PREVOST

WARRANTY BULLETIN

WB14-42A

DATE :	AUGUST 2014	SECTION :	06 - Electrical
EXPIRATION:	AUGUST 2016		
SUBJECT :	GATEWAY MODULE POWER SOURCE

Figure 1

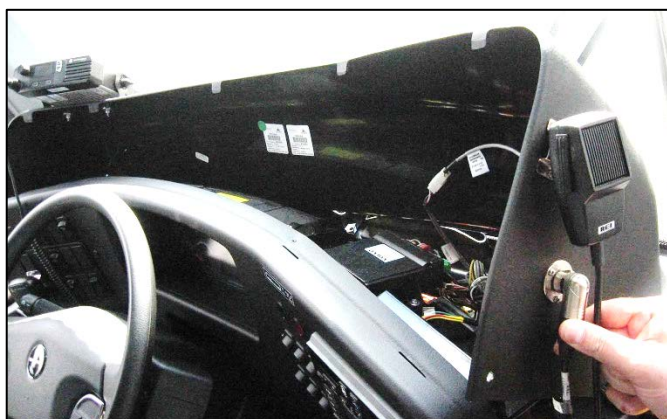
- A1. Remove the dashboard cover (5 screws).

Figure 2

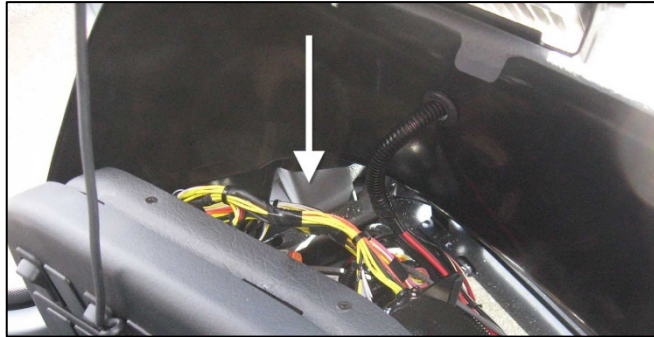
- A2. Locate gateway module. It is installed flat, behind the left portion of the dashboard.
- A3. Check module revision label. (Fig 4)
If it is **SM320 REV:A SW REV:1.00** and up, jump to **STEP B** below.

Figure 3

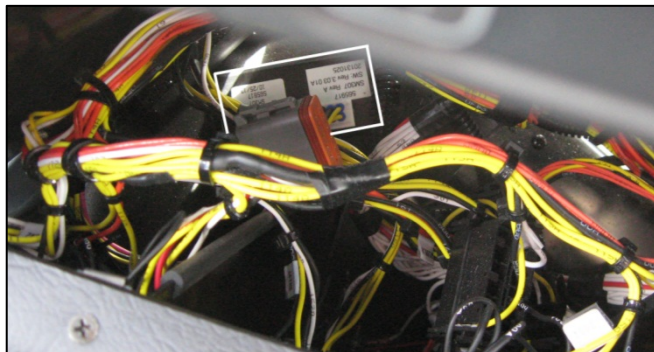
- A4. Unscrew module (2 screws). Disconnect cable.
- A5. Keep old module for parts return.
- A6. Replace by a new module **565921**. New module must be revision **SM320 REV:A SW REV:1.00** and up.

Figure 5

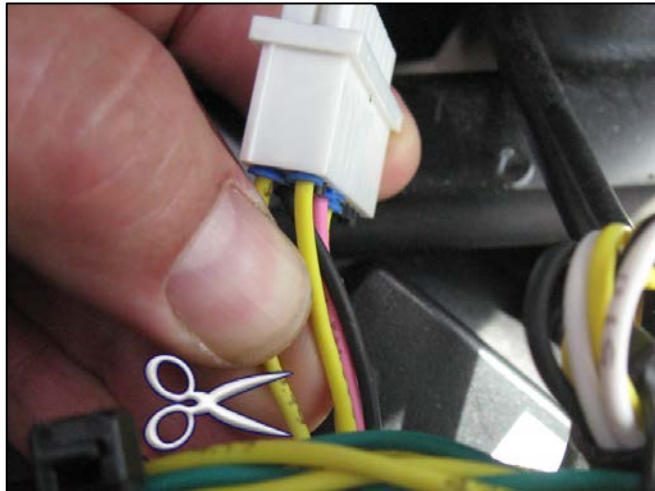
- B1. Unplug Connector to Gateway module A139.
- B2. Locate wire **439** at **pin 1** of Gateway Module A139. (Fig 5)
- B3. Cut about two inches away (50mm) from connector. (Fig 5)

Protect and seal bare wire end coming from dash with shrink tubing.

Figure 6

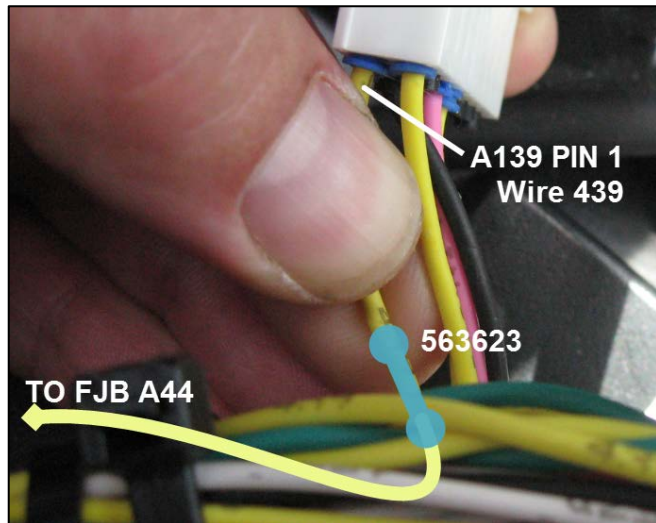
- B4. Run a new yellow 16ga **GXL** wire (560661 or equiv.) from A44 module in Front Junction Box to Gateway module.

Strip and connect to wire 439 coming out of gateway module connector pin 1 and new wire from front service compartment (FJB).

Use thermal shrink butt splice 563623. (Fig 6)

Figure 7

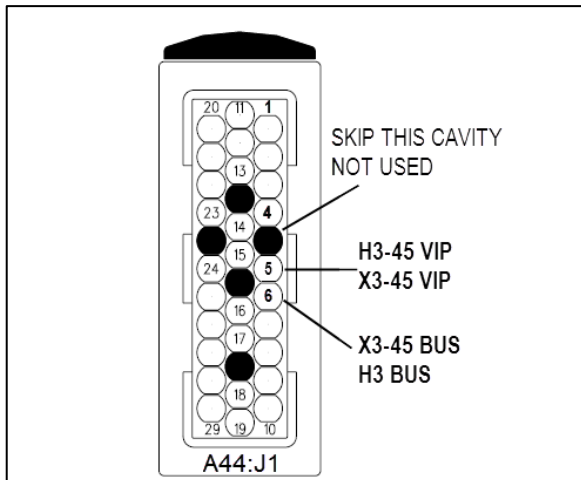
B5. Connect new wire to **A44:J1** using terminal 563692. (Fig 7)

Pin: 5 for H3-45 **VIP** and X3-45 **VIP**.

Pin: 6 for H3 **BUS** and X3-45 **BUS**
